CHILDREN'S HOSPITAL
OF ORANGE COUNTY

TOWER II Received
June 05 2012
McCarthy

LEVEL 4 FLOOR PLAN

A3.41

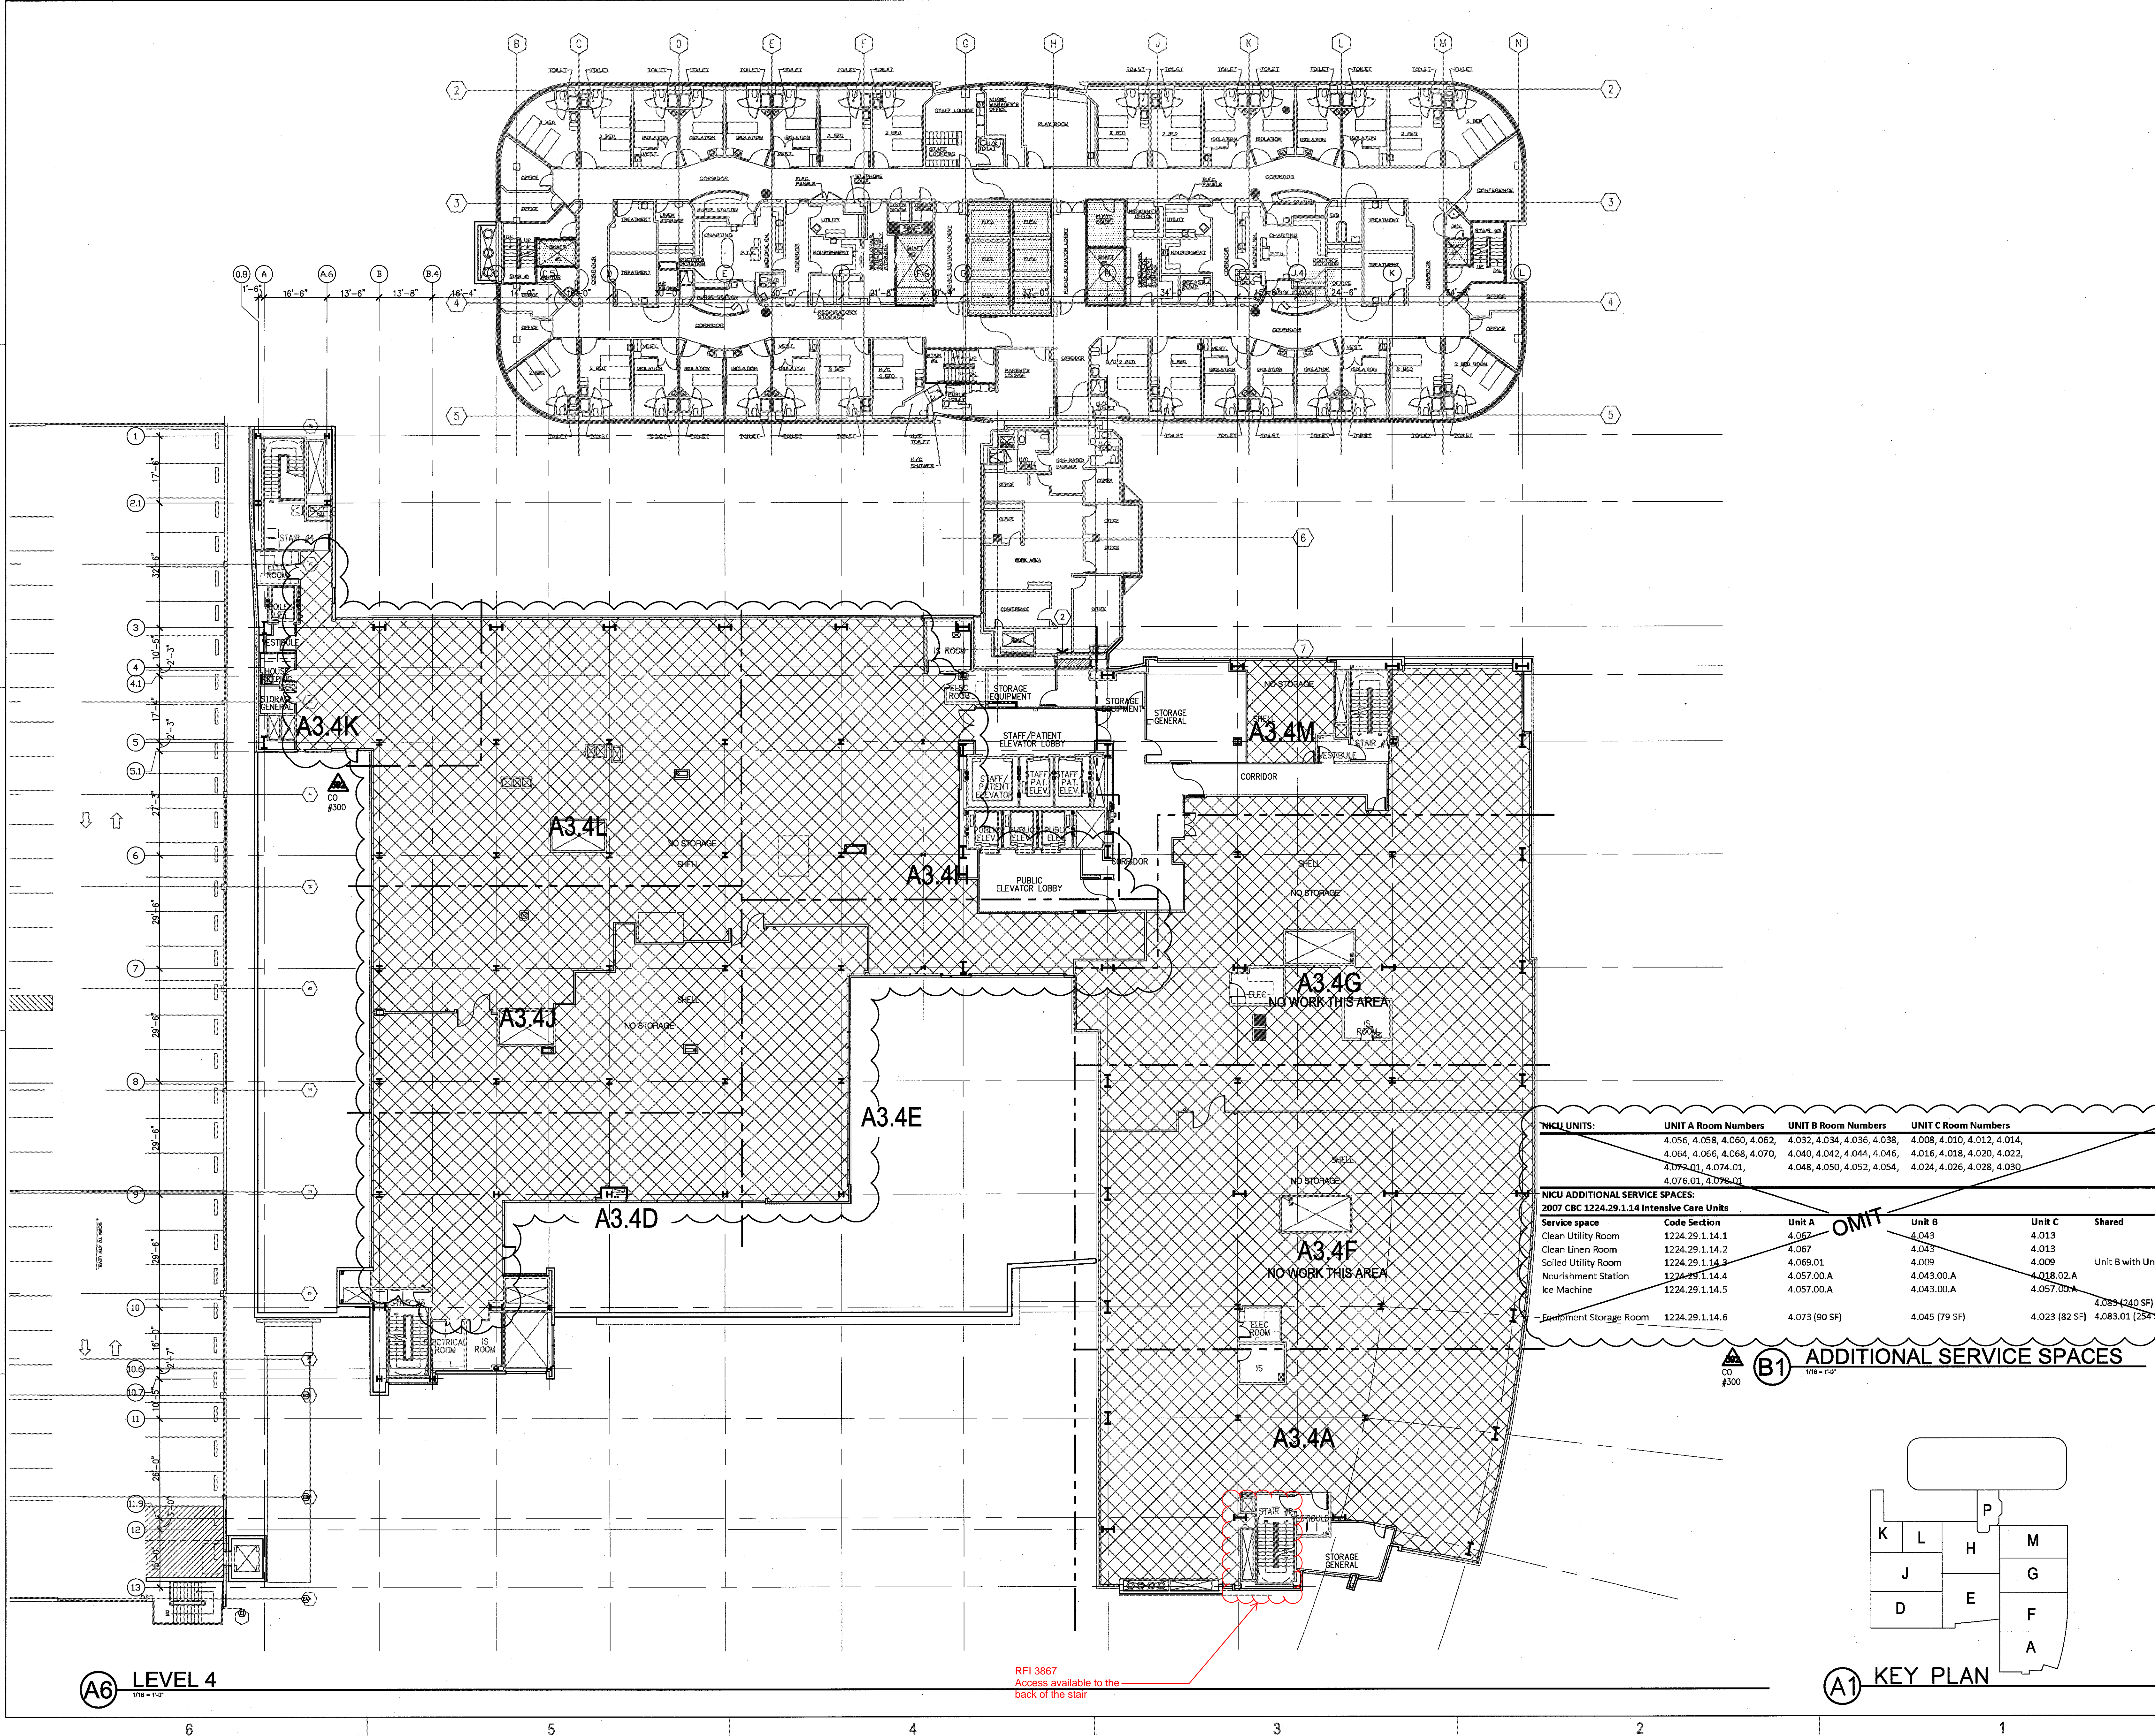
RFI 3867
Access available to the
back of the stair
